From: Moran, Alan P. <APMoran@columbus.gov>
Sent: Thursday, April 18, 2024 4:16 PM
To: Law, Mark W.
Subject: RE: You're Invited to:DPS 3973E FRA--11-15.80 Noise Wall Stage 2 (2nd Review) 18 Apr 2024

From: Moran, Alan P.
Sent: Tuesday, February 20, 2024 2:48 PM
To: Law, Mark W. <MWLaw@columbus.gov>; Roberts, Doug <MDRoberts@columbus.gov>
Subject: FW: You're Invited to:DPS 3973E FRA--11-15.80 Noise Wall Stage 2 (2nd Review) 20 Feb 2024

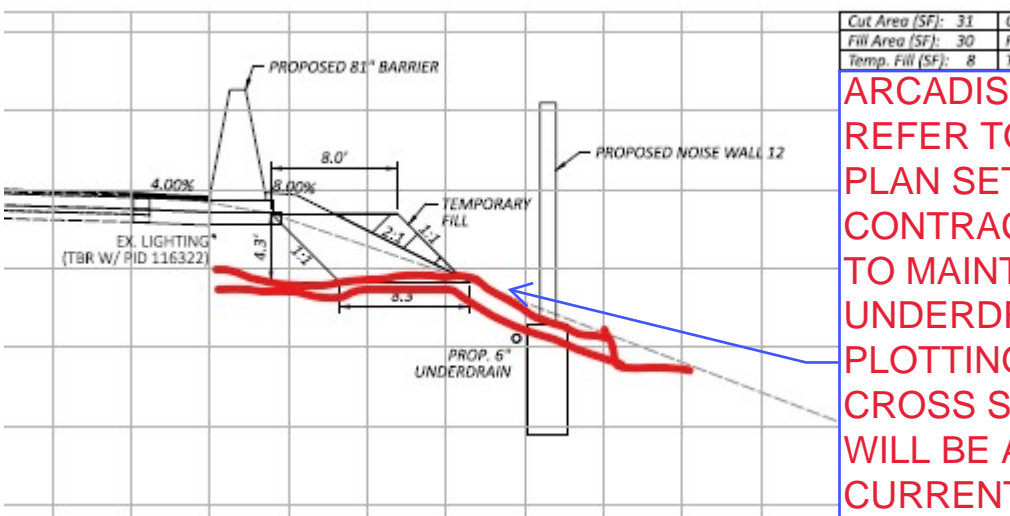
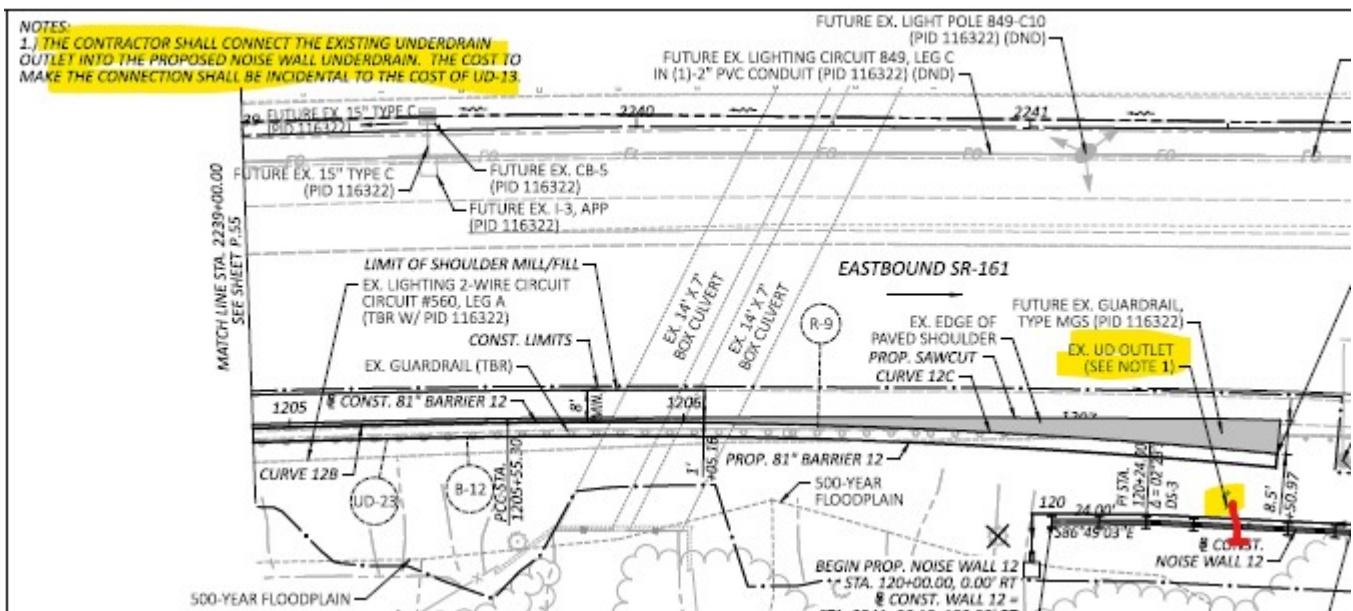
The proposed solution at Barrier 12 for Outlet #106400 does give me some concern that the roadway base drainage at that location would be dependent on the underdrain system for the noise wall. Instead, can the roadway underdrain outlet be extended beyond the Noise Wall 12 allowing it to outlet to the ditch?

ARCADIS RESPONSE: PLEASE REFER TO PAGE 182 OF THE PLAN SET FOR NOTES AND CONTRACTOR REQUIREMENTS TO MAINTAIN POSITIVE UNDERDRAIN OUTLET. AFTER PLOTTING THE OUTLET IN THE CROSS SECTION, THE OUTLET WILL BE ABLE TO DRAIN AT IT'S CURRENT LOCATION AND WILL NOT REQUIRE TO BE EXTENDED UNDER THE NOISE WALL.
